APPLICATION NO.	FILING DATE	FIRST NAMED INVENTOR	ATTORNEY DOCKET NO.	CONFIRMATION NO.
09/900,951	07/10/2001	Natsuhiko Mizutani	35.C15550	7967

Office Action Summary

DETAILED ACTION

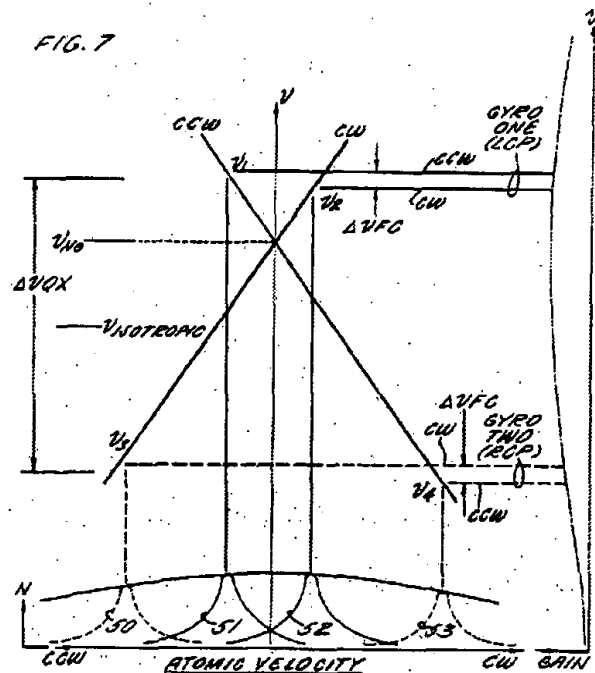
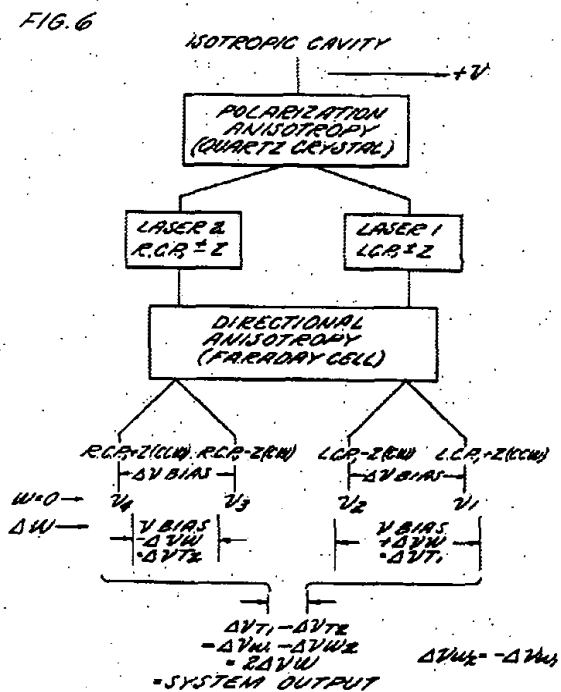
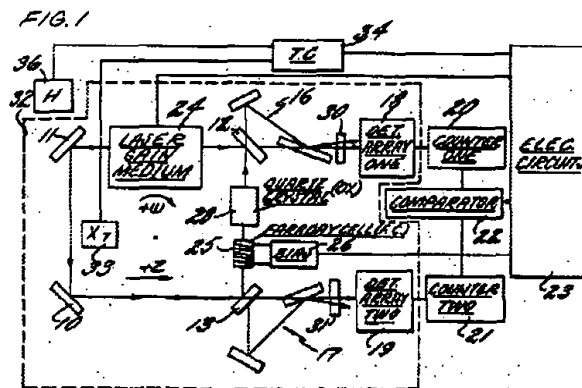
Claims 1-3, 5-8, and 10 are rejected under 35 U.S.C. § 102(b) as being clearly anticipated by Yntema et al(3,862,803).

Yntema et al teach a differential laser gyro system comprising a square ring laser with mirrors(10-13), laser gain medium(24), Faraday bias cell(25), and quartz crystal(28); left circularly polarized(LCP) gyro output(16,30), and detector(18); right circularly polarized(RCP) gyro output(17,31), and detector(19); counters(20, 21); comparator(22); and control electronics(23). See figure 1. Due to the effects of the Faraday cell and the polarization anisotropic quartz crystal, four different beams are produced inside the ring laser. A first gyro is formed by counter-rotating LCP beams while a second gyro is formed by the counter-rotating RCP beams. Because the beams are oppositely circularly polarized they are optically independent. The effects of angular velocity on the different gyros is opposite, as the beat frequency between the LCP beams increased the beat frequency between the RCP beams would decrease. See also figures 6 and 7.

With regard to claims 1, 3, and 5-8; the LCP and RCP gyros meet the claimed limitations.

With regard to claim 2, the LCP and RCP have the same beat frequency when stationary.

With regard to claim 10 the gyro is not formed on a semiconductor substrate.

第 7 図

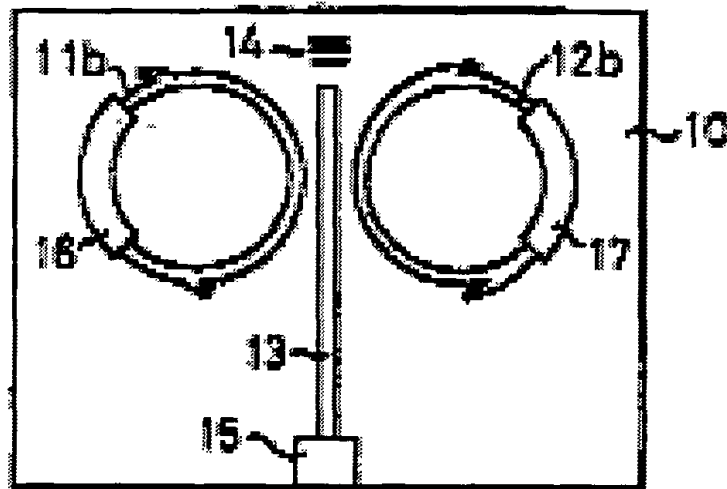
Hideo teaches a semiconductor gyro having two ring lasers(11,12), an output waveguide(13), and a detector(15). Not taught is driving the ring lasers with a constant current and detecting the voltage or current change, or where the driving current or voltage is the same for each ring laser.

第 2 圖

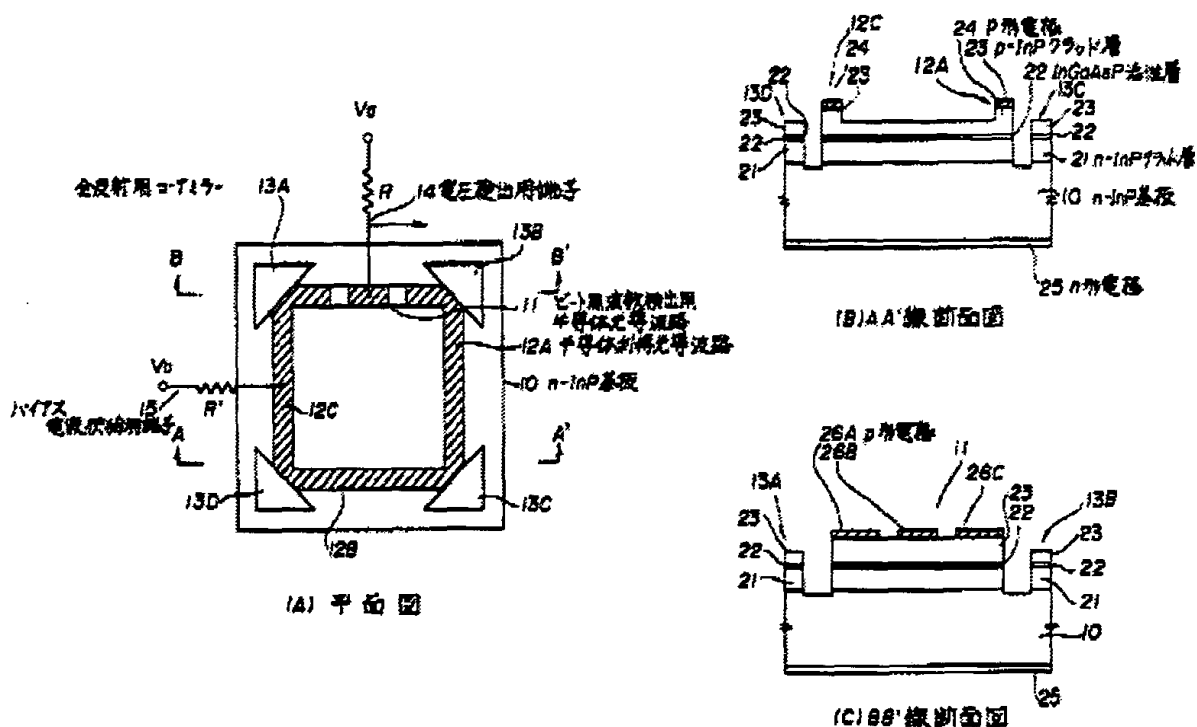
Masahiro teaches a semiconductor ring laser gyro comprising a substrate(10), ring resonator(11,12a-12c), corner mirrors(13), electrodes(24 and 26a-26c), oscillation current is supplied from source V_a, and a bias current from bias source V_b. See figure 2.

skill in the art to modify the output of Hideo by replacing the optical output with current/voltage measurement found in Masahiro.

With regard to claims 17-20; it would have been obvious to one of ordinary skill in the art to replace the uni-directional rings of Hideo with the ring laser as taught by Masahiro, while maintaining the opposite bias between the two ring lasers to improve the gyro sensitivity.
